Access Compliance Report

Public Rights-of-Way

Intersection ID: N/A	Main Street: MACDARA_GLENN_CT	Cross Street: FIVE_KNOLLS_DR	Location: SE
ADA ID: 055137DC44F2	Ramp Type: PerpDiag	Initial Pass/Fail: Fail	Overall Compliance: No
Codes/Mitigation Info/Possible Solution		Field Measurements/Component Compliance

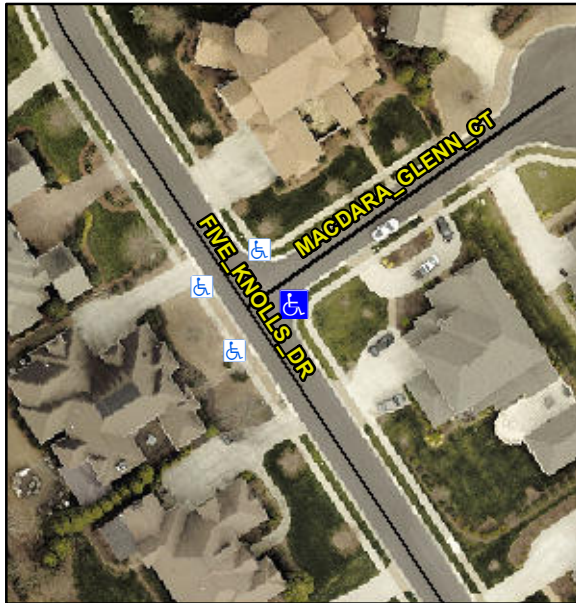
Compliance	Description	Data	Compliance	Description	Data
N/A	Ramp Length (in)	46.5	No	Ramp Slope (%)	9.0
Yes	Ramp Width (in)	48.0	Yes	Ramp XSlope (%)	0.2
N/A	Flare Type LT	N/A	N/A	Flare Type RT	N/A
N/A	Flare Slope LT (%)	N/A	N/A	Flare Slope RT (%)	N/A
N/A	Flare Traversable LT?	N/A	N/A	Flare Traversable RT?	N/A
N/A	Landing Length (in)	N/A	N/A	DWS Provided?	N/A
N/A	Landing Width (in)	N/A	N/A	DWS Contrast?	N/A
N/A	Landing Slope (%)	N/A	N/A	DWS Length (in)	N/A
N/A	Landing X Slope (%)	N/A	N/A	DWS Full Width?	N/A
N/A	Landing Curb? (Y/N)	N/A	N/A	DWS Offset (in)	N/A
N/A	Shared Landing?	N/A			
N/A	Gutter Ponding?	N/A	N/A	Gutter Slope (%)	N/A
N/A	Gutter Lip Ht (in)	N/A	N/A	Gutter X Slope (%)	N/A
N/A	Painted X Walk1?	No	N/A	Painted X Walk2?	No
	X Walk 1 Direction	To N		X Walk 2 Direction	To W
N/A	X Walk 1 Width (in)	N/A	N/A	X Walk 2 Width (in)	N/A
	X Walk 1 Slope (%)	1.1		X Walk 2 Slope (%)	1.9
	X Walk 1 X Slope (%)	0.8		X Walk 2 X Slope (%)	1.1

N/A	Ramp inside XWalk1?	N/A	N/A	Ramp inside XWalk2?	N/A
	Road Slope (%)	1.6	N/A	Clear Space?	N/A
	Road X Slope (%)	2.1	N/A	Clear Space to XWalk (in)	N/A
N/A	Any Obstructions?	N/A	N/A	Storm Grate/Utility Hazard?	N/A
	Obstruction Type			Storm Grate/Utility Type	
		N/A			N/A
			Yes	Surface Condition? (G/P)	Good

Remove & Replace Curb Ramp With Two New Directional Ramps or Equivalent.
